UNITED STATES PATENT AND TRADEMARK OFFICE

APPLICATION NO.	FILING DATE	FIRST NAMED INVENTOR	ATTORNEY DOCKET NO.	CONFIRMATION NO.
10/815,440	04/01/2004	Richard J. Macor	APT0404	7786

Office Action Summary	Application No. 10/815,440	Applicant(s) MACOR, RICHARD J.	
	Examiner Hadi Shakeri	Art Unit 3723

DETAILED ACTION

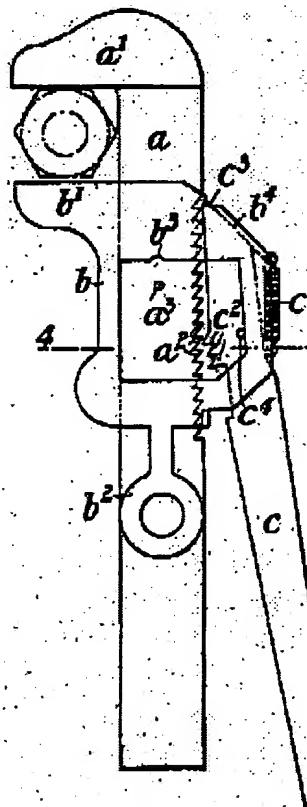
6. Claims 1, 2, 9 and 10 are rejected under 35 U.S.C. 102(b) as being anticipated by Stocker (588,365).

Stocker discloses all of the limitations of claims 1 and 9, i.e., an adjustable type pliers tool comprising a first tool member pivotally attached to a second tool member, each said tool member having a handle portion (c, a), and a head portion (b, a¹) comprising a jaw (b¹, a¹); said first tool member being formed having a slot, said second tool member being formed having pin (a³) attached thereto for interaction with the slot of said first tool member, the head portion of said first tool member having a distinct outer shape when said plier tool is viewed from a side view thereof, the distinct outer shape comprising a first section, a second section and a third section with the second section positioned between said first and third sections, and, the first section having a substantially convex curved outer shape, the second section having a substantially concave curved outer shape, and, the third section having a substantially convex curved outer shape so as to provide said adjustable plier tool with excellent jaw engagement accessibility, wherein the slot extends generally perpendicular to the work engaging surface.

Regarding claims 2 and 10, Stocker meets the limitations, e.g., second jaw having the distinct outer shape (third section just above b²).

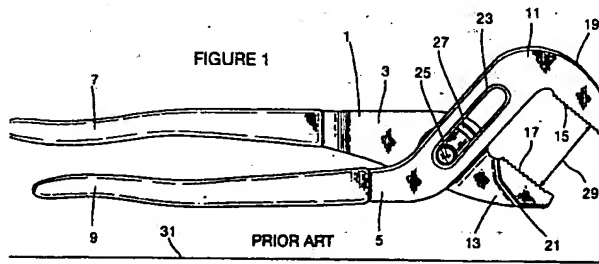
8. Claims 3, 4, 6-8, 11-14 are rejected under 35 U.S.C. 103(a) as being unpatentable over Stocker.

Stocker as applied above meets all the limitations of the above claims, except for disclosing an overall tool length being between 5 and 6 times the maximum spacing between the jaws. Stocker appears to disclose a ratio of about 6.5, i.e., 103 mm overall length and 16mm maximum spacing. However, choosing the overall length to be shorter for ease of storage and/or carrying, e.g., of about 90 mm would be well within the knowledge of one of ordinary skill in the art.

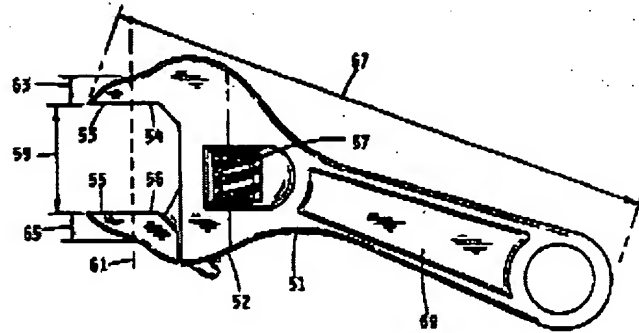
Macor teaches accessible adjustable wrench having the distinct outer shape and specific dimension ratios, e.g., shorter handle lever. It would have been obvious to one of ordinary skill in the art, at the time the invention was made, to modify the invention of AAPA with the jaw

shapes and overall dimensions as taught by Macor to adapt the tool for engaging and accessing fasteners located in limited access environment.

With regards to the overall dimension relative to the maximum spacing of the jaws, Macor teaches a ratio of less than 7, including embodiments (e.g. less than 6) meeting the open ended range of claims 3, 7, 11, 13, 17 and 19, with regards

to claims 4, 6, 8, 12, and 18, further modifying the range for a particular application, e.g., between 5 and 6, would be well within the knowledge of one of ordinary skill in the art and since it has been held that where the general conditions of a claim are disclosed in the prior art, discovering the optimum or workable ranges involves only routine skill in the art. *In re Aller*, 105 USPQ 233.
